Is there a problem when 3.3V of MOS output and EN Pullup are connected to Vin (5 V to 12 V)?

Circuit of question 2

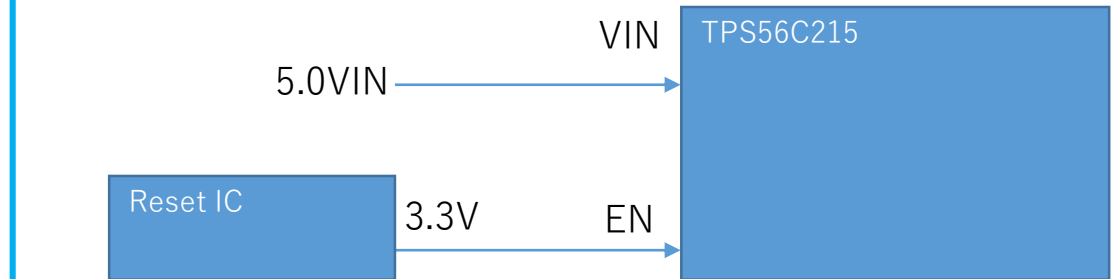
We thought that it was possible to cope with the turn around of the power supply with the following circuit.

I understood that 2 is better than 3.
Is this correct?
